HISTORIC AND DESIGN REVIEW COMMISSION

HDRC CASE NO: 2015-406
ADDRESS: 975 E SOUTHCROSS
LEGAL DESCRIPTION: NCB 7665 BLK LOT 35 TERMINAL FREIGHT INC SUBD.
ZONING: I1 H RIO-5
CITY COUNCIL DIST.: 3
DISTRICT: Mission Historic District
APPLICANT: Xavier Gonzalez/GRG Architecture
OWNER: NATMI National FX Properties LLC
TYPE OF WORK: Final approval of new construction
REQUEST:

ASCENT RECYCLING - NEW STRUCTURES

BIRDSEYE VIEW

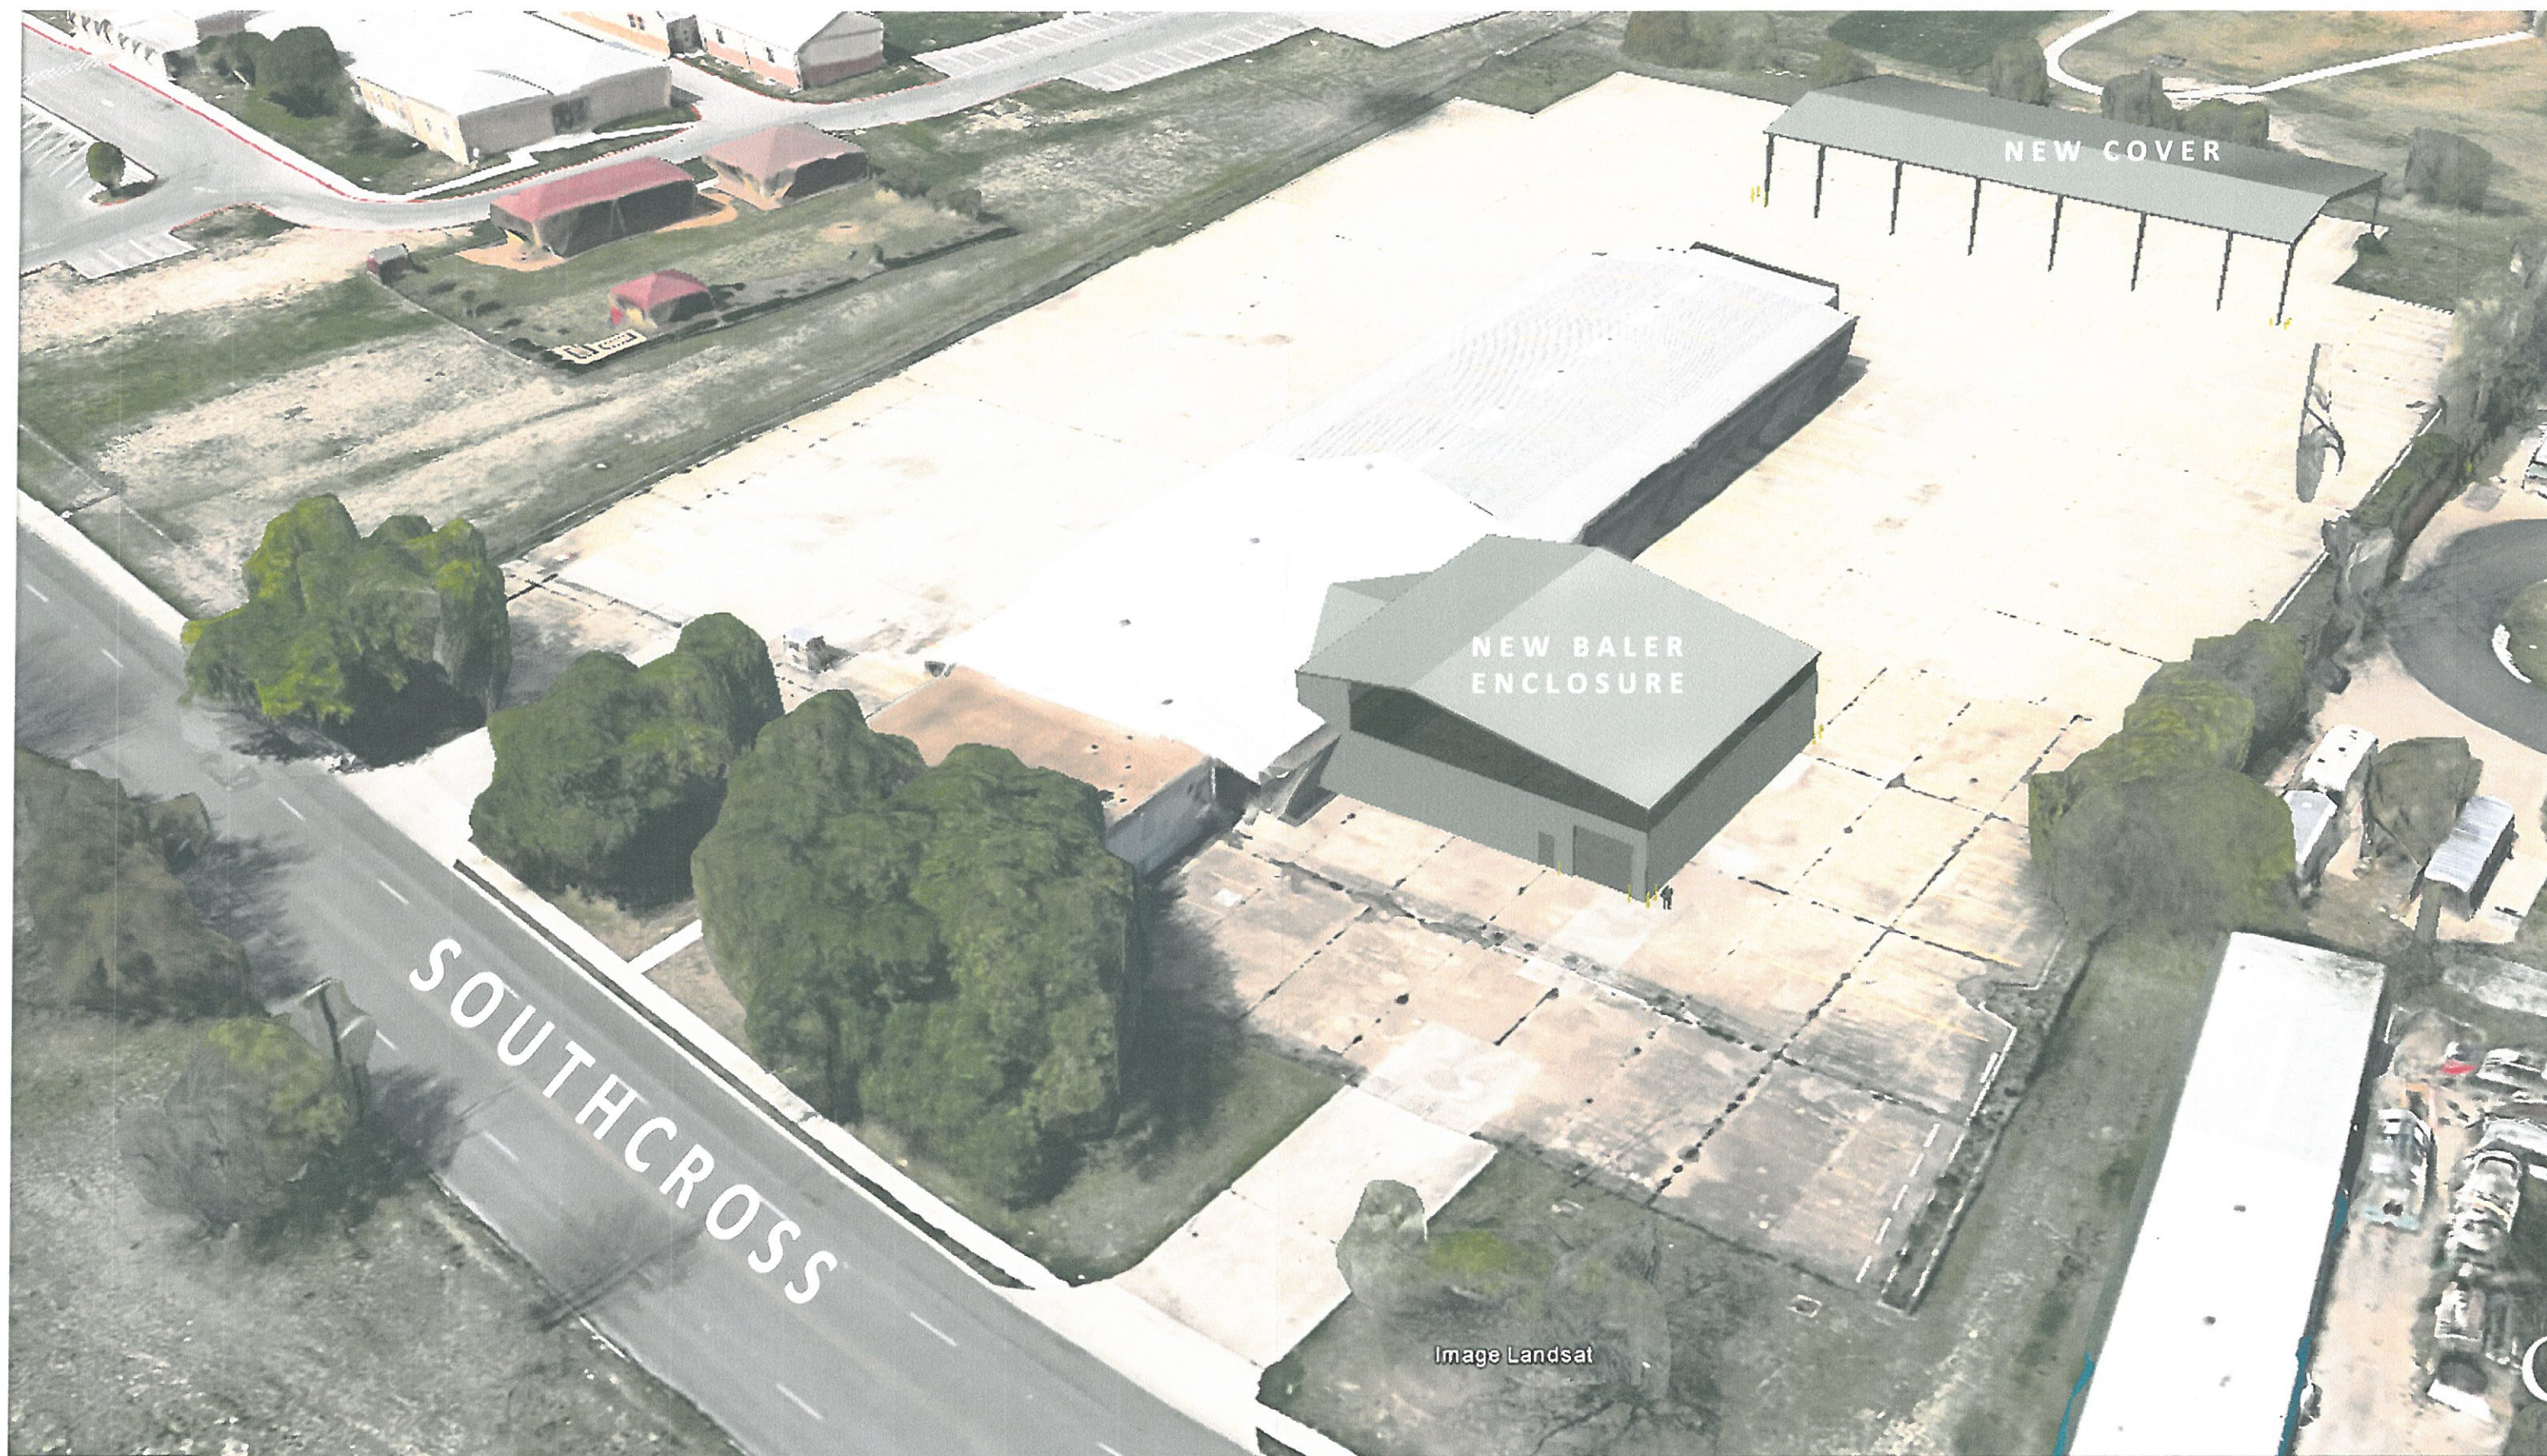
- b. Per the UDC Section 35-673(b)(1)(A), two or more buildings on a site should be clustered to create active open spaces such as courtyards along the street and river edges. Furthermore, According to 35-673(b)(2), primary and secondary entrances should be oriented toward the street and shall have architectural features that distinguish themselves as such. The applicant's proposal is not consistent with the UDC.

Staff does not recommend approval based on findings a through g. Staff recommends conceptual approval of the proposed placement of the addition and covered structure.

3 ELEVATIONS & SECTION - BAILER ENCLOSURE
1/16" = 1'-0"

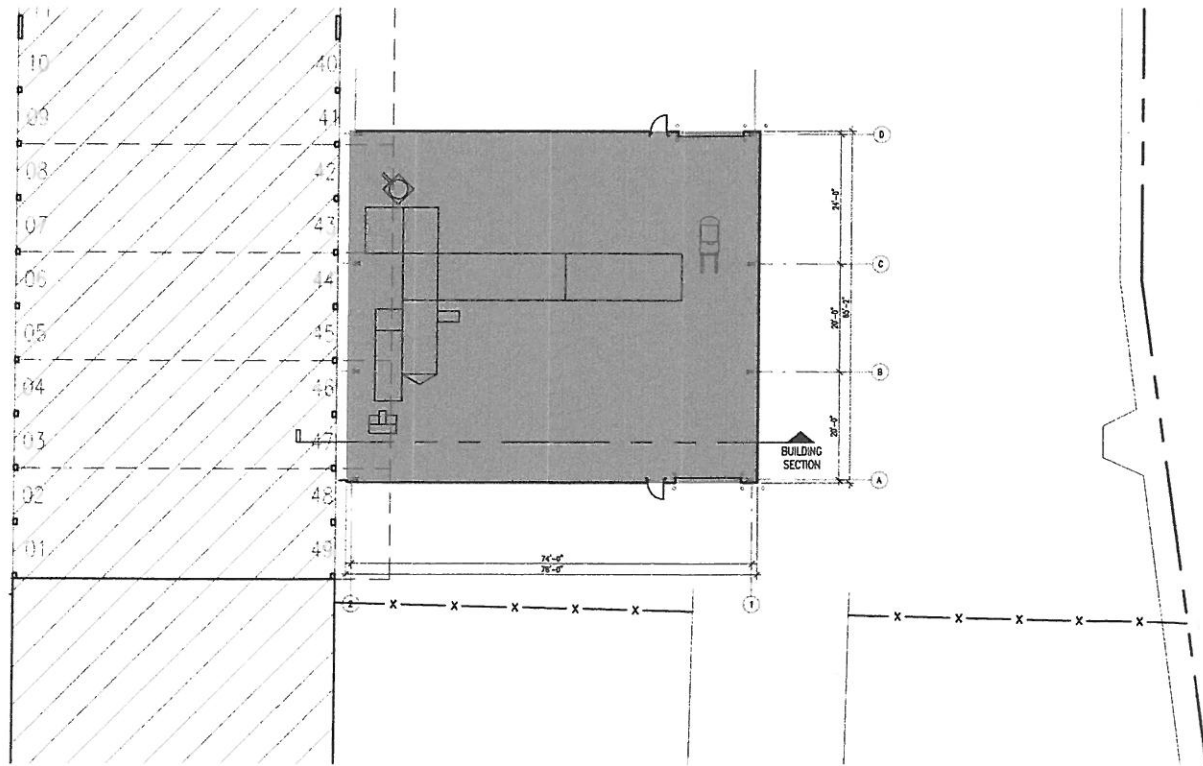
- d. New construction in the RIO shall appear to have a human scale. In general, this scale can be accomplished by using familiar forms and elements interpreted into human dimensions. The applicant has proposed for the baler enclosure to feature large metal walls void of architectural openings. The applicant has proposed for the new open air structure to feature a steel frame with a cover raised approximately 25' to 30' above grade. Neither of these proposals consist of a human scale. The applicant's proposal is not consistent with the UDC.

- e. Regarding materials and finishes for new construction in the RIO, both should include elements that provide a sense of human scale, reduce the perceived mass of a building and appear to blend with the natural setting of the river. The applicant's proposed metal panels, perforated metal panels and steel structure do neither of these in regards to promoting a sense of human scale. This proposal is not consistent with the UDC Section 35-674(d).

- f. Per the UDC Section 35-674(e), facades should include three distinct elements, a base, midsection and cap. Each of these elements contribute a sense of scale to a building. The applicant has not proposed a base, mid section nor cap to be consistent with the UDC.
